Submission of Further Information (FI)

**Temporary Private Vehicle Park (Excluding Container Vehicles) and Associated Filling
of Pond for a Period of 3 Years in “Village Type Development” Zone,
Various Lots in D.D. 113 and Adjoining Government Land, Yuen Long
(Application No. A/YL-KTS/1129)**

Further Information for Planning Application No. A/YL-KTS/1129**Response-to-Comments****Comments from the Drainage Services Department**

Plan 7.2
(P 25098)

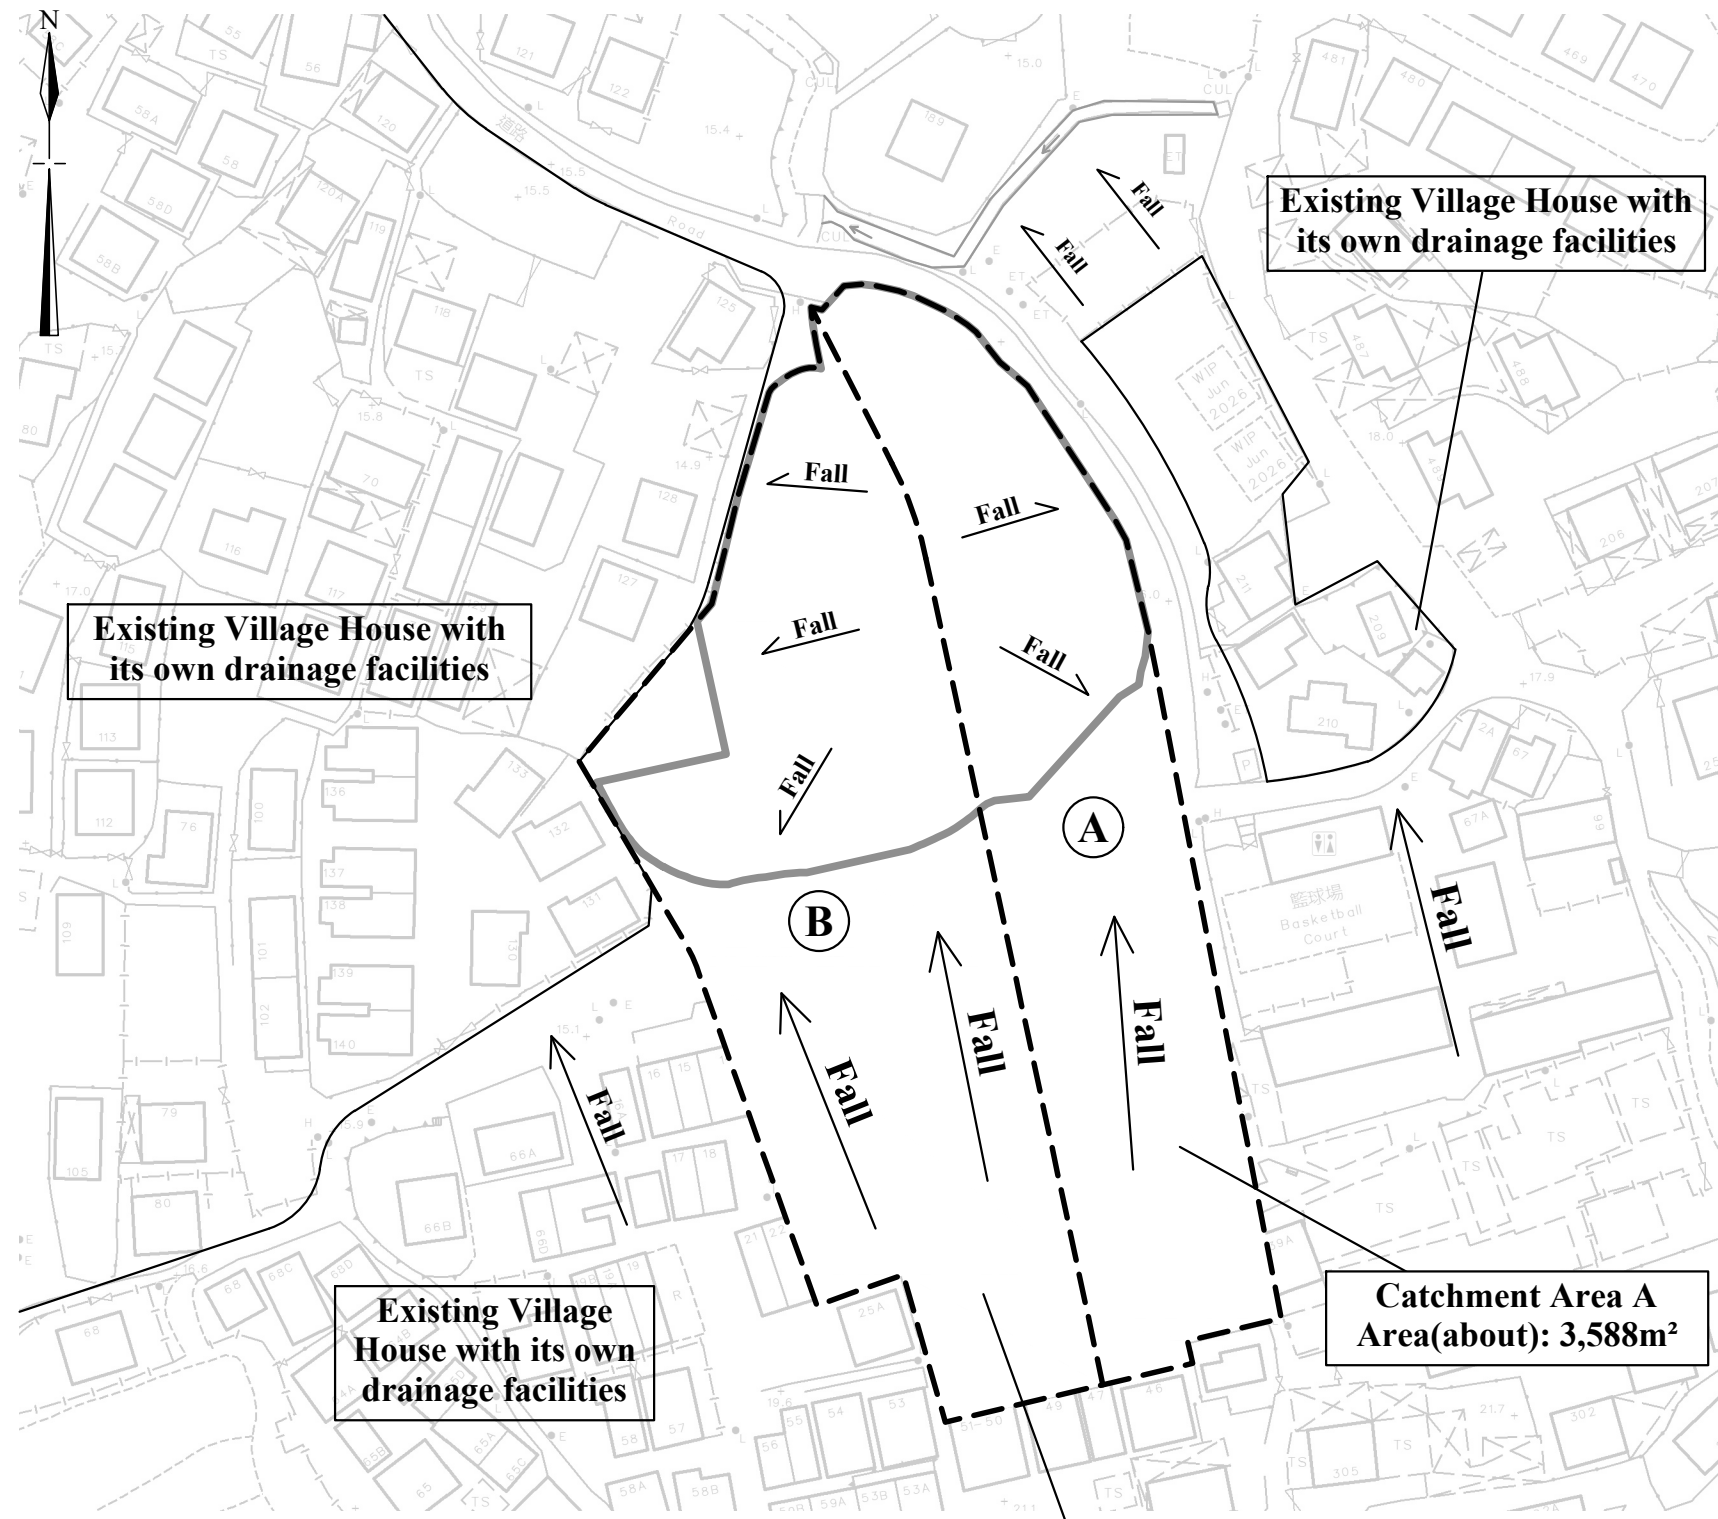
I.	Comments	Responses
1.	We are unable to provide comment on drainage aspect of the application at this stage. Comment on drainage aspect will be provided when the drainage proposal as mentioned in paragraph 19 of the planning statement is received. Please advise whether any discharge connection(s)/paths to the pond will be affected due to the proposed filling of the existing pond. A detailed assessment should be provided to demonstrate that the proposed filling of pond will not cause any adverse drainage impact/flooding to the adjacent lands for comments before the proposed filling works.	Please see the drainage proposal (Plans 7.1 & 7.2), site photographs (Viewpoints 1 to 7) and hydraulic calculations for details. We would like to clarify that the pond within the Site has been filled for over 25 years. No further filling works is proposed. Existing drainage facilities have been constructed to collect the surface runoff and overland flow. The development would not cause adverse drainage impact/flooding to the adjacent lands.
